# WATERBURY FILING NO. 1

## FINAL PLAT

**WATERBURY FILING NO. 1  
FINAL PLAT**  
A PORTION OF SECTIONS 28, 29 AND 33, TOWNSHIP 12 SOUTH,  
RANGE 64 WEST OF THE SIXTH PRINCIPAL MERIDIAN  
EL PASO COUNTY, COLORADO

PCD FILE NO. SF23-07

| SHEET NO     | 7 OF 7   |

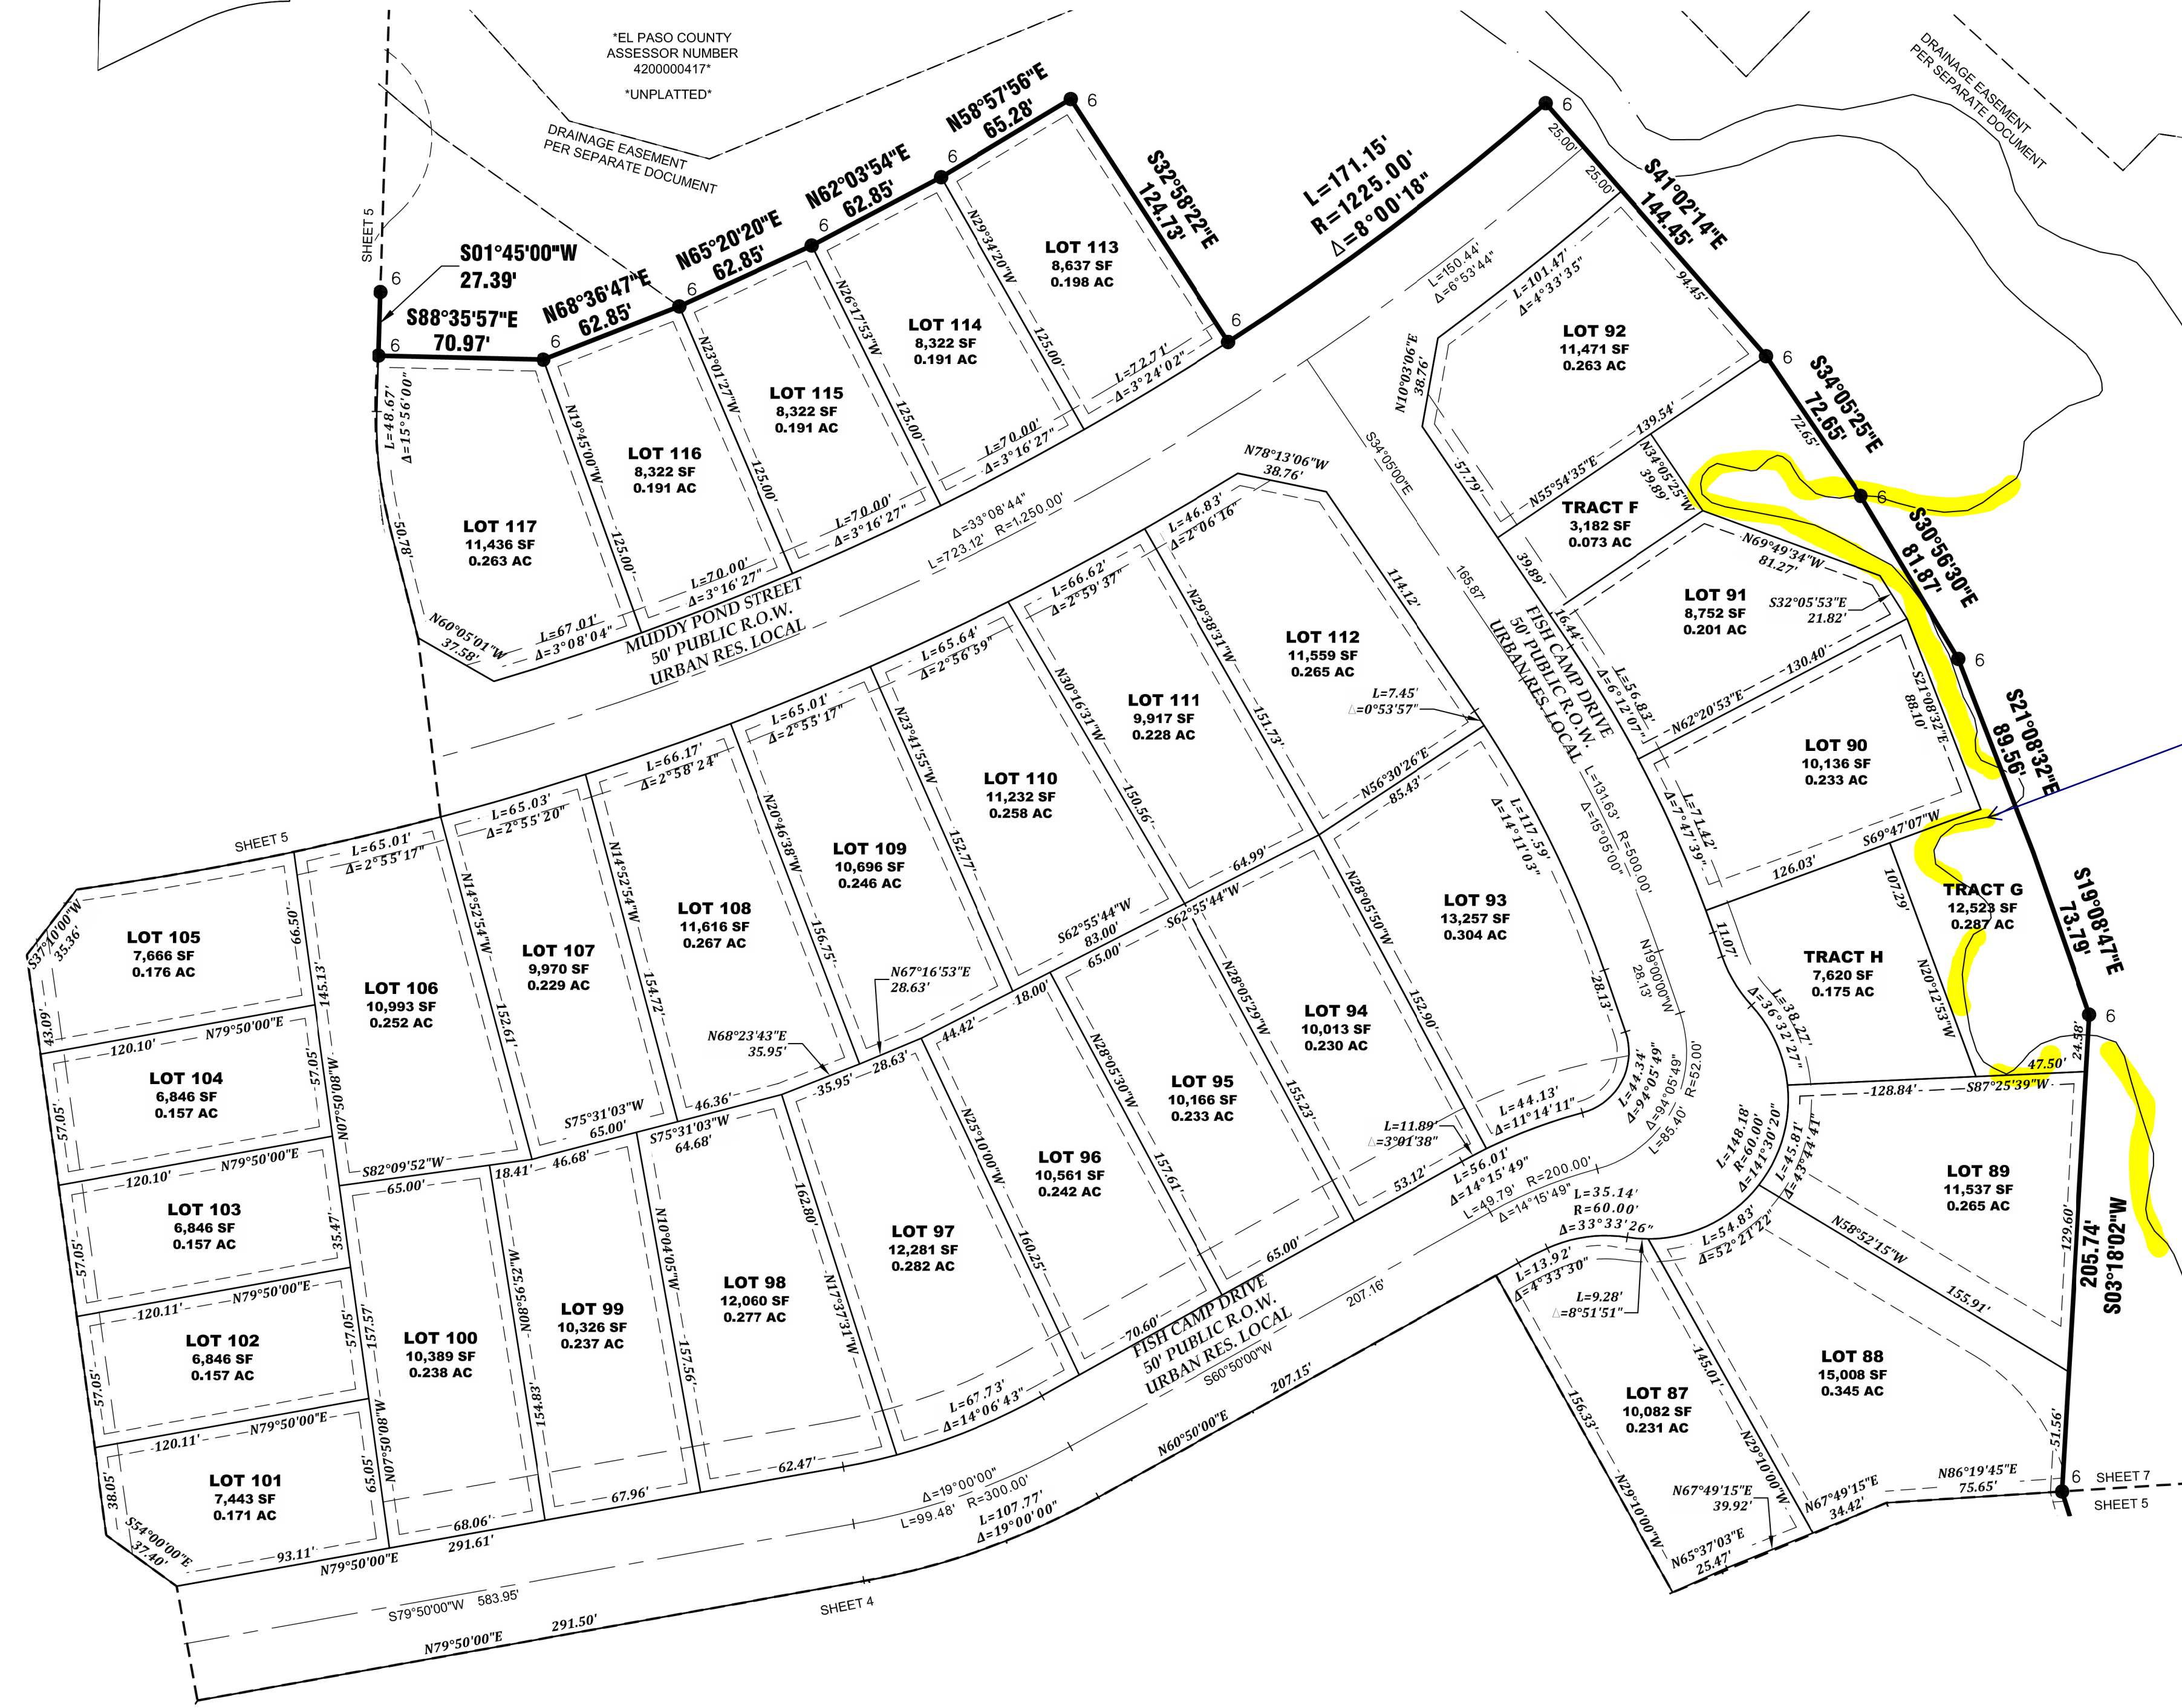
Please label as  
floodplain boundary  
line does not match  
legend

note added  
(line segments are to close for  
the line type to work in this area)
